# KINGSTON FOSSIL PLANT

ANNUAL ASH POND DIKE  
STABILITY INSPECTION  
2008

Prepared by: Jamey Dotson  
Date: February 15, 2008

Fig. 1 Sluice Channels to Ash Pond

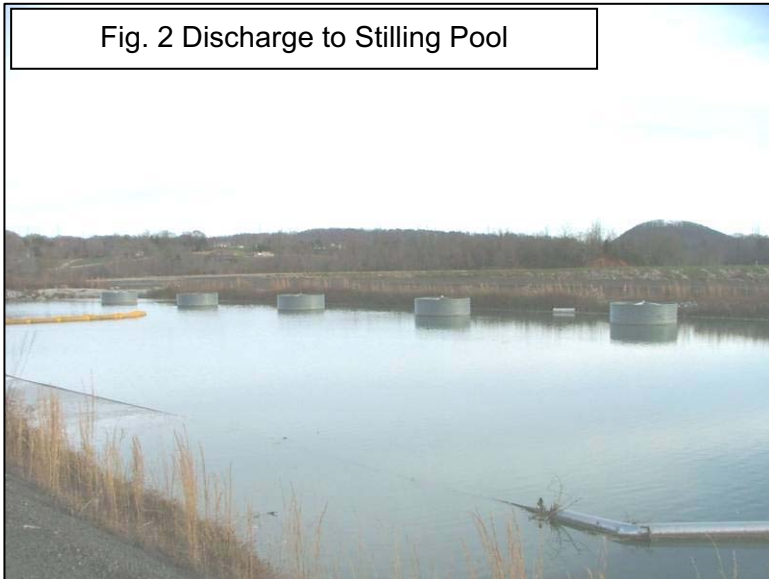
Fly ash is sluiced into an adjacent channel to the bottom ash channel where it flows into the main ash pond. The fly ash channel was cleared of vegetation last year. Both channels flow northeast into the active ash pond. See Figure 1 and drawing API 2008.

Fig. 2 Discharge to Stilling Pool

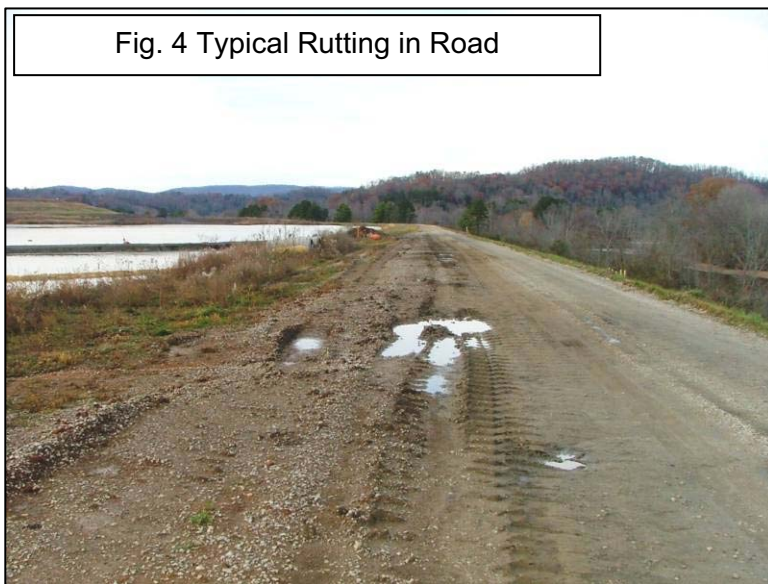
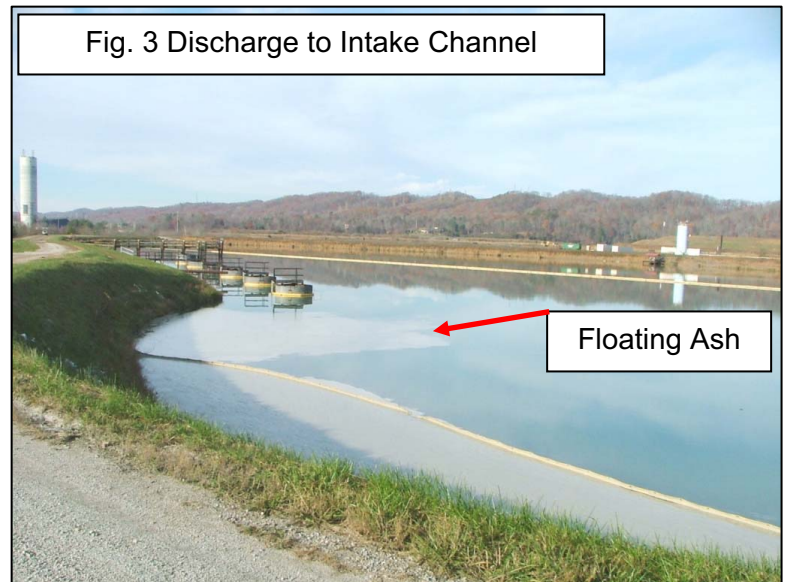
Sluice water flows from the active ash pond into the stilling pond through the five spillways constructed in 2005 (see Figure 2), as part of a project to allow more accurate accounting of free water volume. The old plant constructed spillway (Kennedy Weir) was taken out of operation at the same time. From the stilling pool, the water discharges into the plant intake channel via six standard spillways equipped with discharge diffusers constructed in November 2003. Many of these structures have vegetation and brush growing inside them, which needs to be removed.

excellent vegetative cover. The interior of Dike "C" is showing some signs of erosion at the water line. These areas should be stabilized with riprap to prevent wave action erosion. The dikes had been mowed recently and were in very good condition. The grass on the dike between the stilling pool and the intake channel was only cut halfway down the slope leaving a vegetative buffer zone. Previously, grass clippings from mowing this slope had entered the discharge spillways partially clogging them. This caused the stilling pond level to raise a couple of inches. Plant personnel inquired about spraying this

- Remove vegetation growing inside spillway structures.
- Investigate the use of spraying to inhibit vegetation growth on the interior dikes of the stilling pond.

Fig. 12 Engineered Wetlands

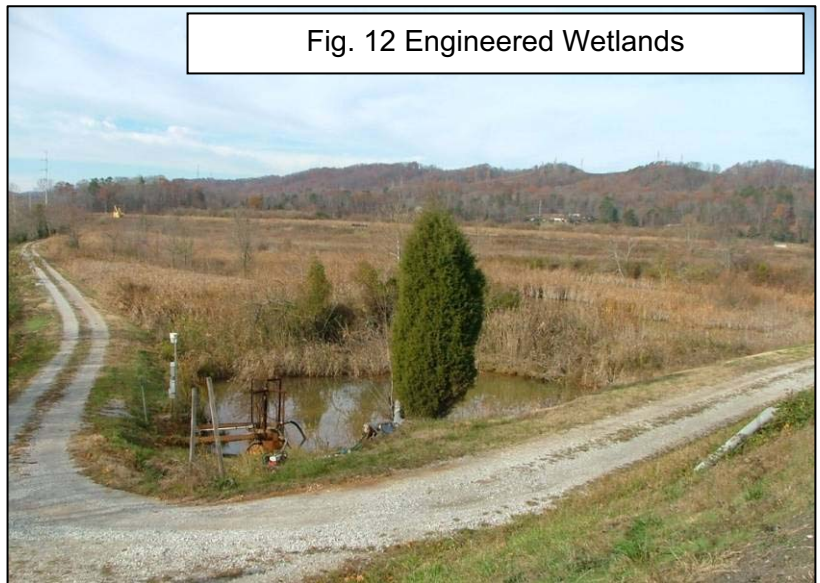
The engineered wetlands along the southwest dike receive seepage that collects in the anoxic limestone drain below the bottom ash trench. The wetland appeared to be functioning, but the discharge is still pumped via two pumps to the ash pond, see Figure 12.

The water levels in the pump structures were at different levels at the time of inspection. There were several trees varying in size growing on the interior dikes of the ponds.

- Remove trees from the slopes of the dikes. Mowing at least twice a year is recommended to control the size of the trees. Preventing the trees from getting larger than 1" in diameter at the ground is preferred. Any trees larger than 3" in diameter at the base must be pulled from the dikes, roots and all. Repair and reseed the damaged area.
